**RE: 628 THOMPSON AVENUE
ADMINISTRATIVE DESIGN REVIEW CASE NO. PDR2119410**

DESIGN REVIEW STAFF REPORT – COMMERCIAL / INDUSTRIAL / MIXED USE

November 7, 2022 <i>Decision Date</i>	628 THOMPSON AVENUE <i>Address</i>
Administrative Design Review (ADR) <i>Review Type</i>	5624-026-003 <i>APN</i>
PDR 2119410 <i>Case Number</i>	BENNY ARIAS <i>Applicant</i>
Aileen Babakhani, Planner <i>Case Planner</i>	JOSE R. REYES <i>Owner</i>

SITE PLAN - PROPOSED SCALE 1/8" = 1'-0" 1

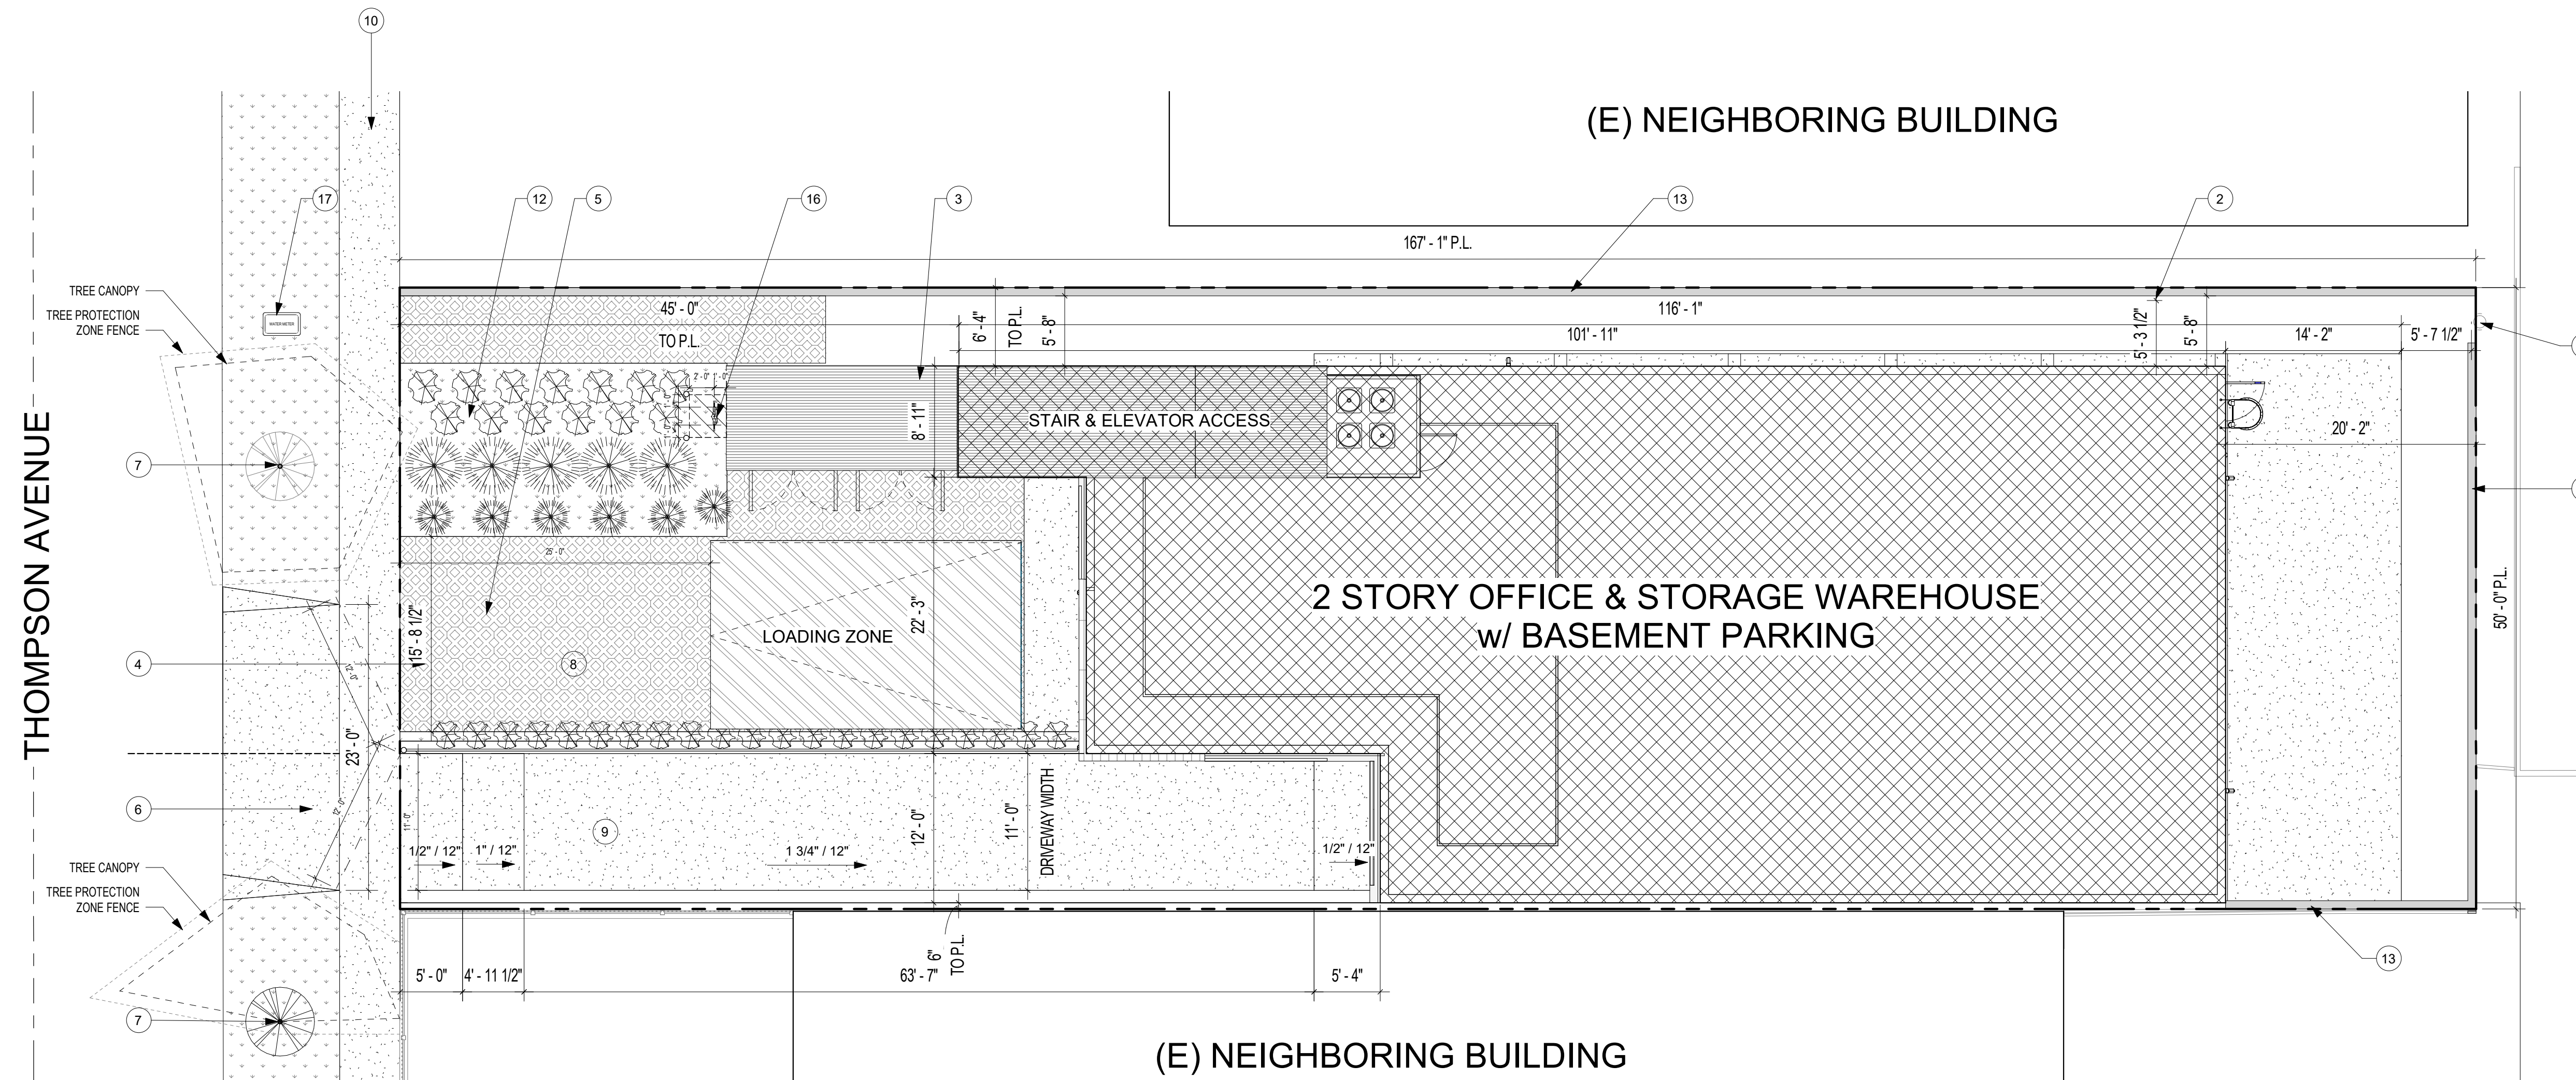
The new driveway access and loading space are appropriate to the site and its neighborhood context. A condition of approval is added for the project to delineate and separate the pedestrian access at the front of the building from the proposed adjacent loading space.

- The project provides pedestrian access from the side of the new building (north) which is clearly delineated with decorative pavers; however, a condition of approval is added for the project to delineate and separate the pedestrian access at the front of the building from the proposed adjacent loading space.
- The project preserves the two existing street trees located on the public right-of-way, adjacent to the building street frontage.
- The proposed rooftop equipment is appropriately integrated into the design and adequately screened from public view.
- The trash bins and recycling containers are located at the front of the building, facing the street; however, they are appropriately screened and new landscaping minimizes the visual impact.

1. Revise plans to delineate and separate the pedestrian access at the front of the building from the proposed adjacent loading space.
2. Update plans to clarify the color of the windows, compatible with the proposed colors and details.
